# Development Review Comments

STP2024-00490

1<sup>st</sup> Submission Review Comments

622 Hungerford Drive – Washington Square

SP-00

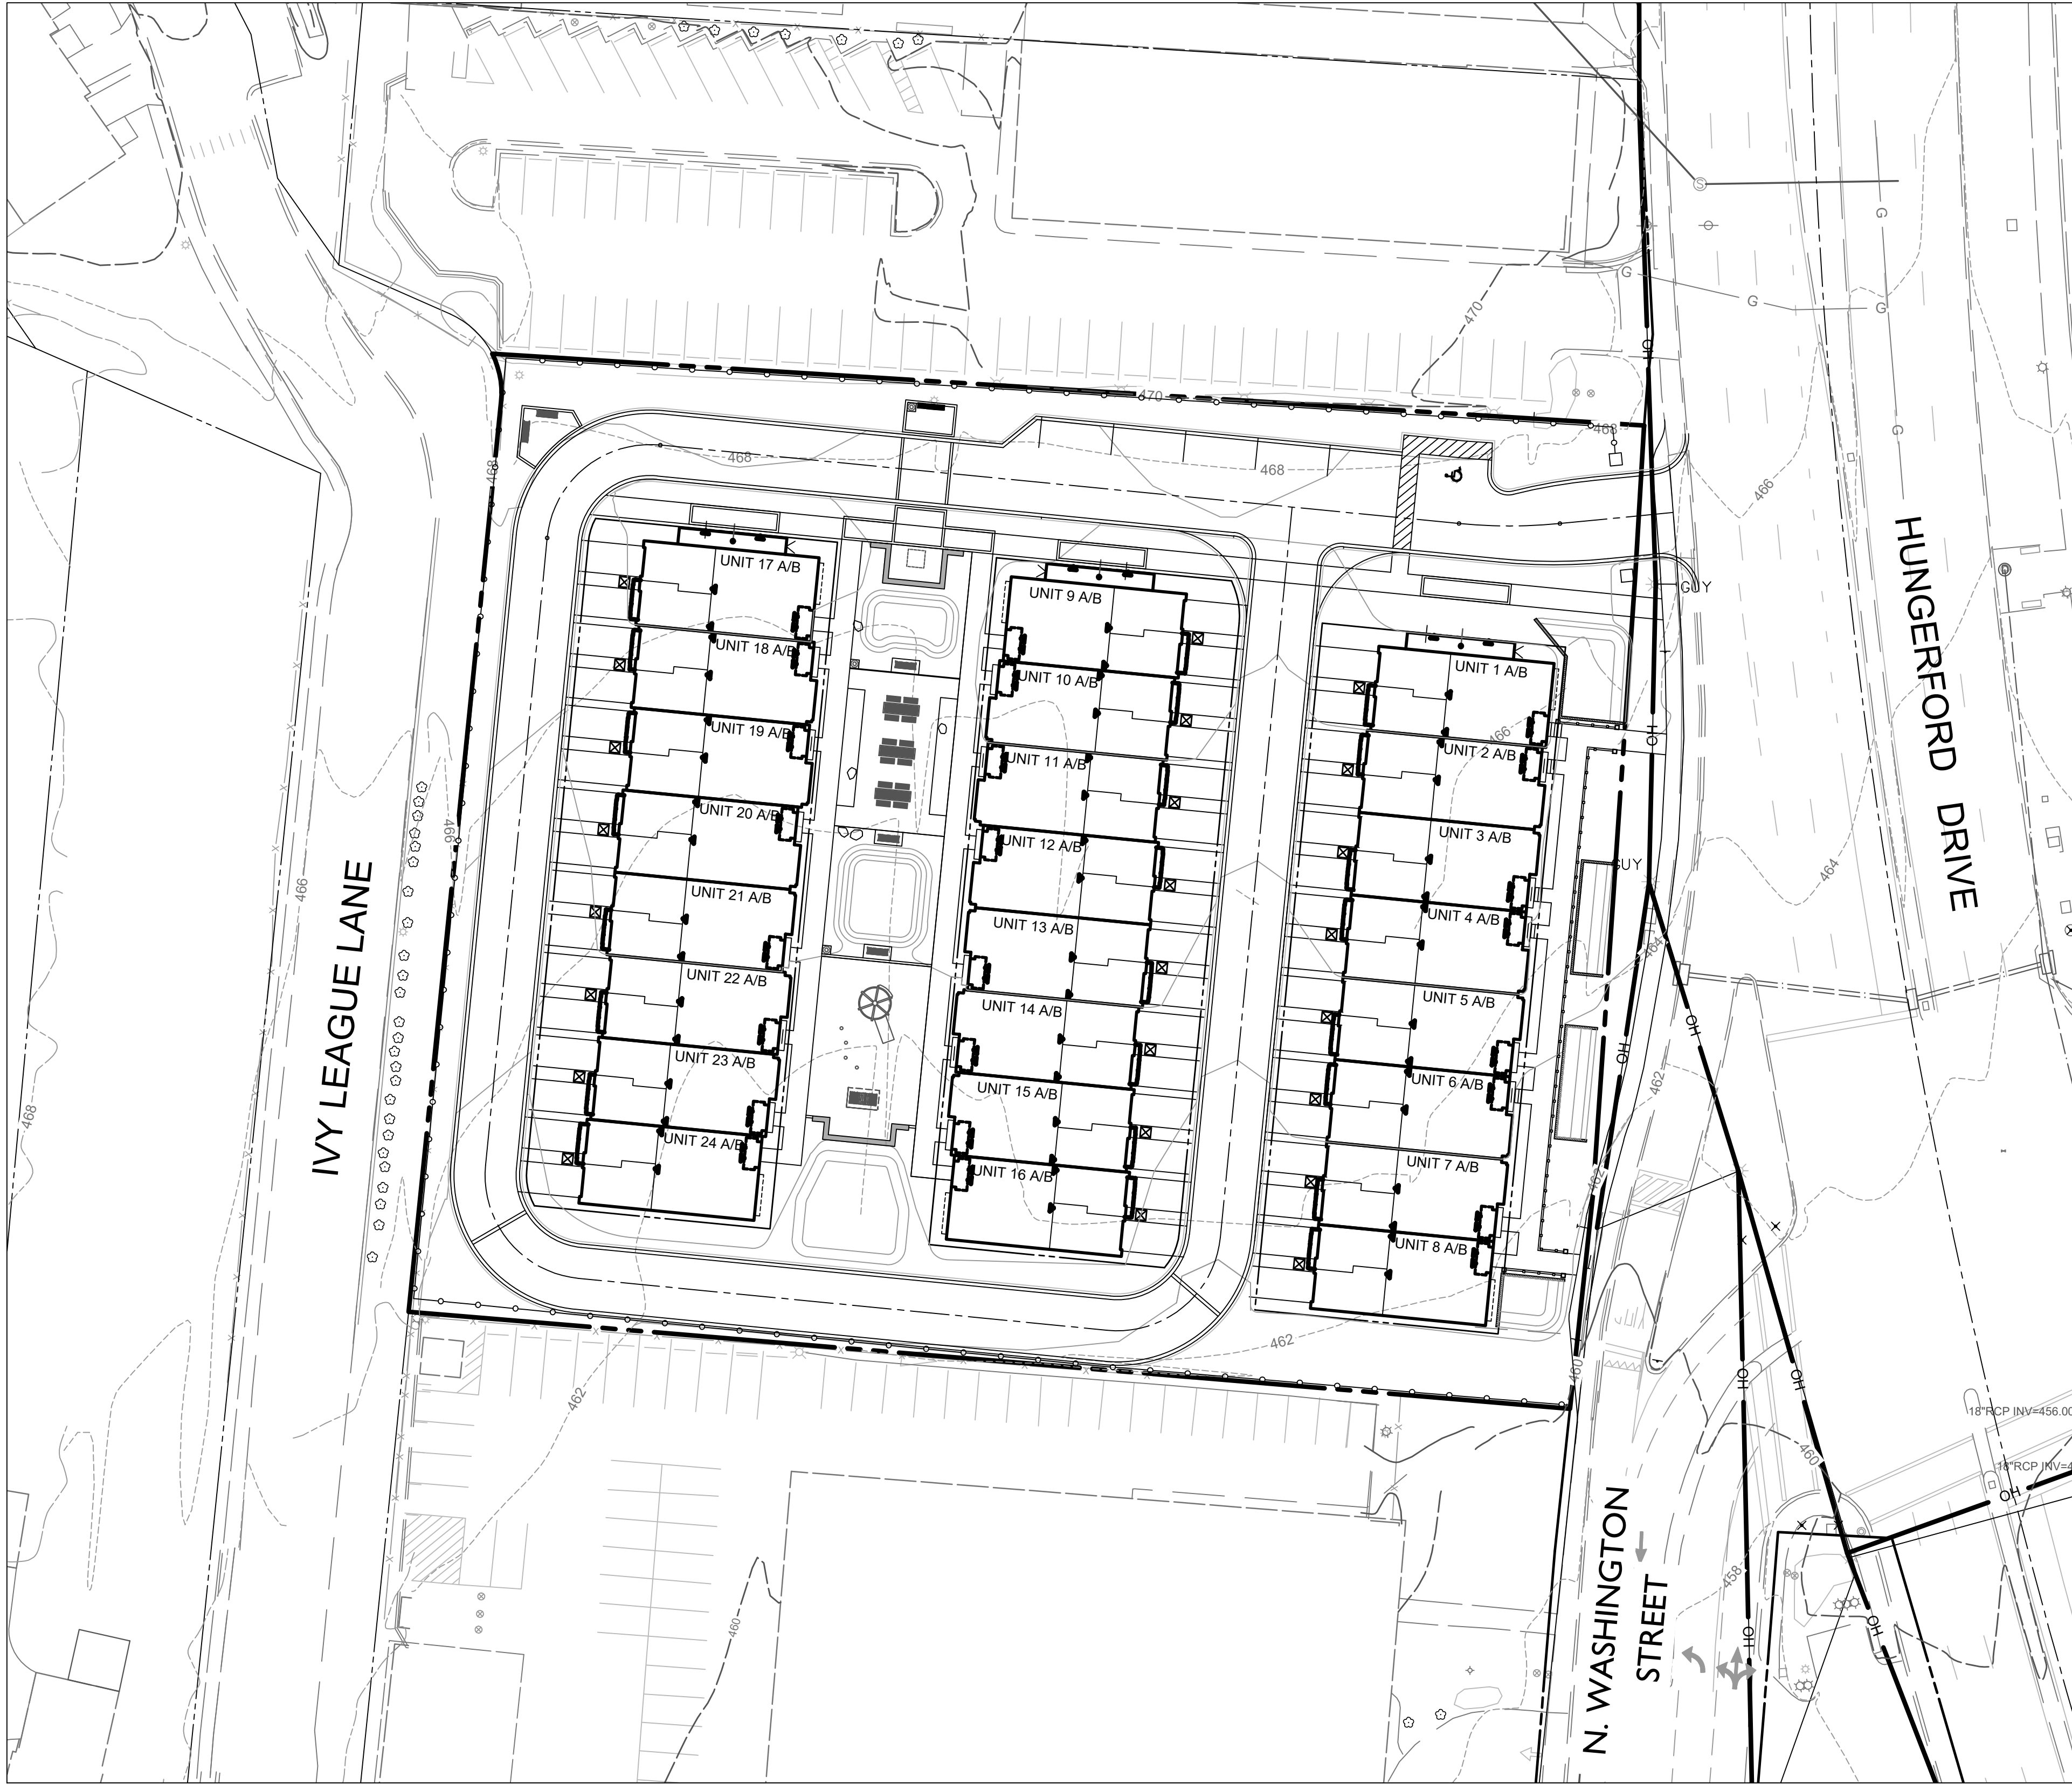
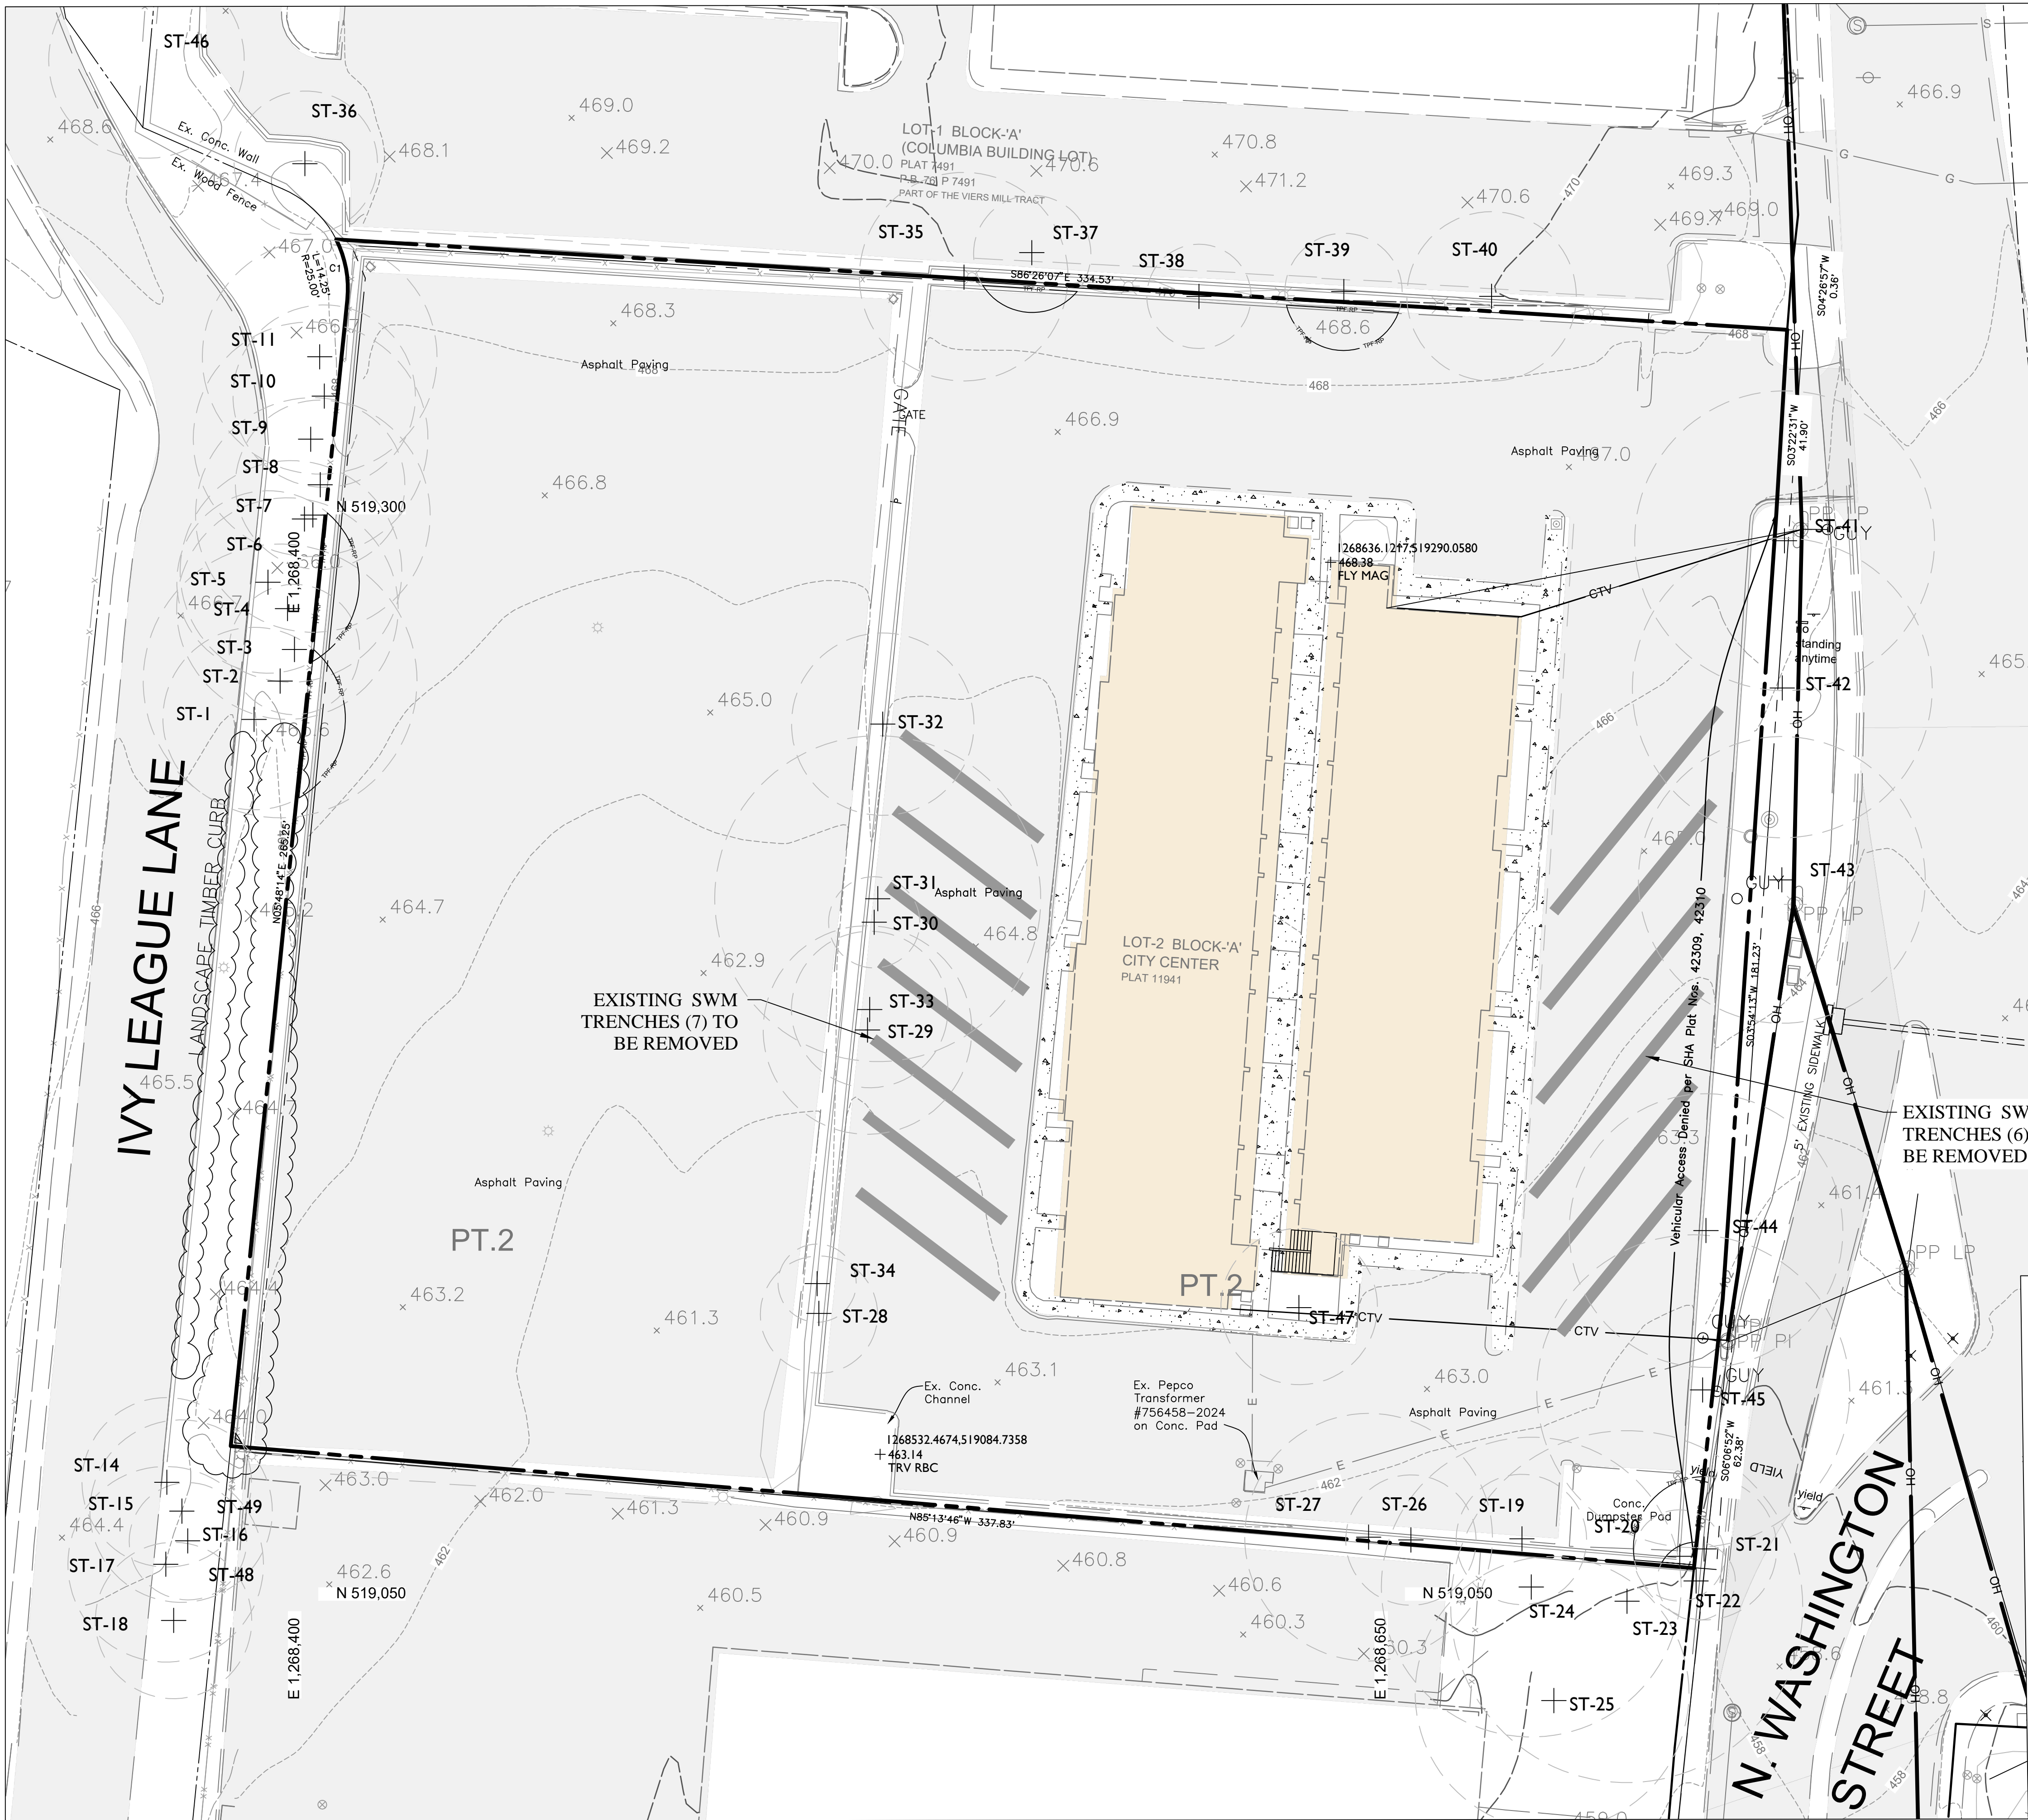
Provide layout per ordinance 25.17.03a. All underground lines and cables shall be placed in a public utility easement, or otherwise on private property. No utilities may be placed in the public right-of-way or on City property without the express written permission of the City, and subject to such terms and conditions that the City may require.

Dry utilities may cross the ROW perpendicular  
Applicant shall submit a conceptual dry utility plan to be approved by both the utility companies and DPW.

#### Provide lotting plan

Lighting Plan  
SCALE: 1" = 20'

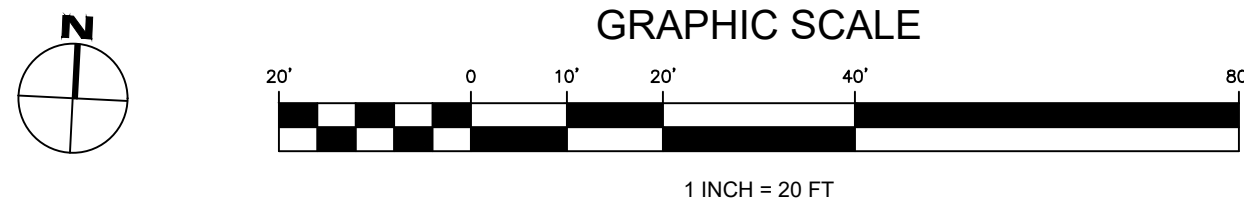
Please delineate between types of lights with different symbols for each on plan
